## Product Change Notification / SYST-01SUTS663

ERRATA - PIC18F27/47/57Q84 Silicon Errata and Data Sheet Clarifications

# PIC18F27/47/57Q84 Silicon Errata and Data Sheet Clarifications

### 1.6.1 UART TXDE Signal May Go Low Before the STOP Bit Has Been Entirely Transmitted

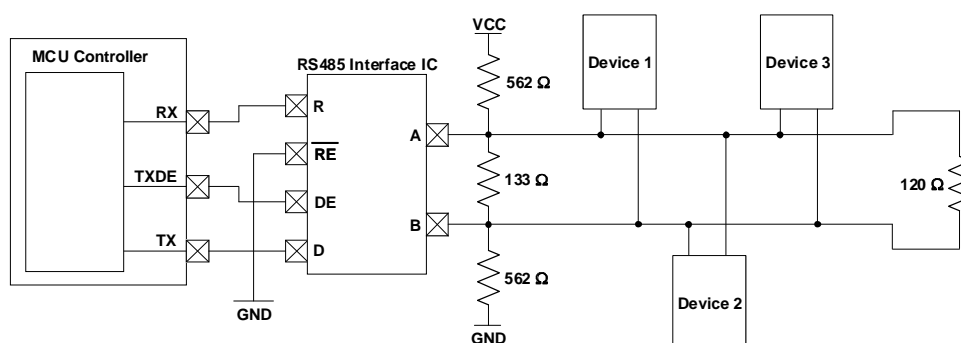
The UART Transmit Drive Enable (TXDE) signal could potentially transition into a low state before the UART STOP bit has been entirely transmitted due to the effects of parasitic capacitance on the TX line. In some applications, this could result in communication being prematurely terminated due to the TXDE bit going low before the STOP bit has had enough time to settle.

To ensure that the STOP bit settles into its final logic state before the TXDE signal transitions low, a biasing circuit can be implemented. A biasing circuit allows the TX line to either be driven high or low, rather than being left in a floating tri-state mode where prolonged rise or fall times could lead to communication being disrupted. This bias circuit should only be implemented on one end of the serial bus, and a termination resistor should be used on the other end. The figure below show an example of a bias circuit that can be used to achieve this.

Please note that the resistor values used in this circuit are recommendations, and that the actual resistor values required may vary based on the application.
